DATE: 2/5/97 ADDRESS: 164 Congress St

REASON FOR PERMIT: Change of use

LAND USE - ZONING REPORT

REASON FOR PERMIT: change of use to 3 families

*Proposed
3rd floor*

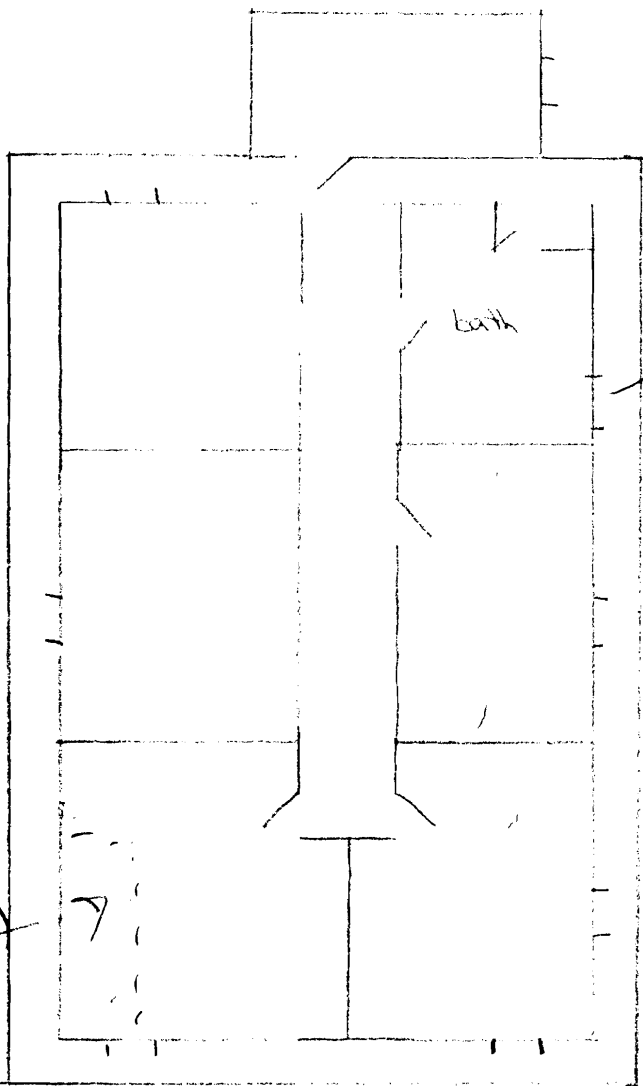
9. Other requirements of condition there shall be no open outside stairways or fire escapes added to this building
10. full construction plans and details for the 3rd floor's 2nd means of egress shall be approved prior to work on the unit (separate permit required)

Per owner
 These are
 windows — these
 are windows in
 the main sand road
 per ^{potential} owner (Anne
 Becker)
 2/4/97

3rd floor current layout

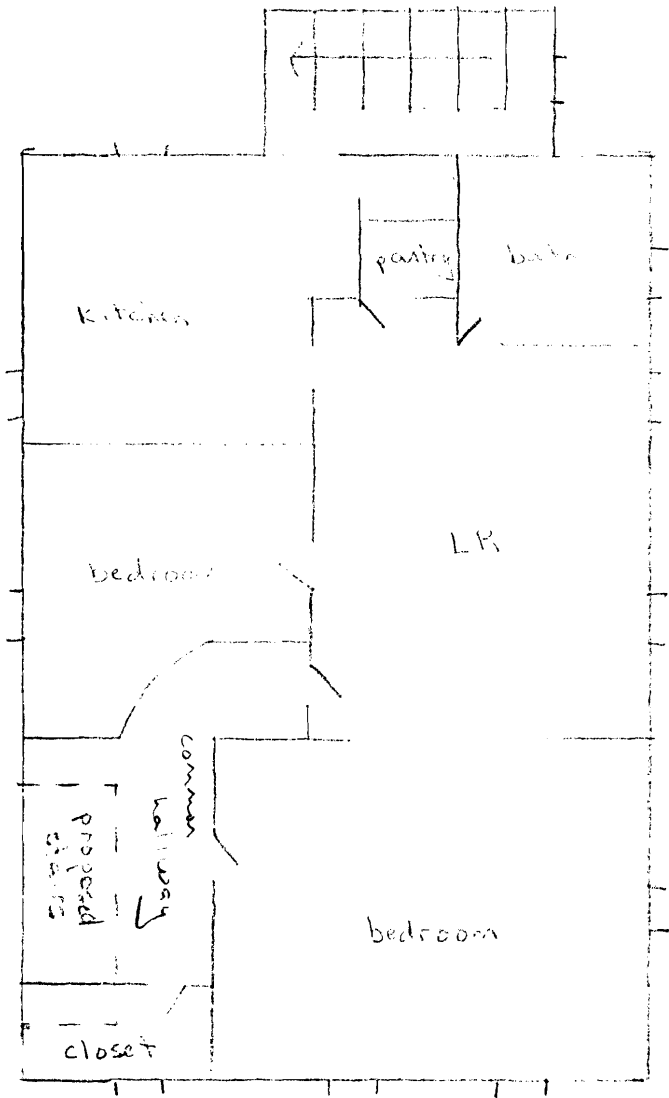
Proposed
 New Stairwell
 to be
 included in separate permit
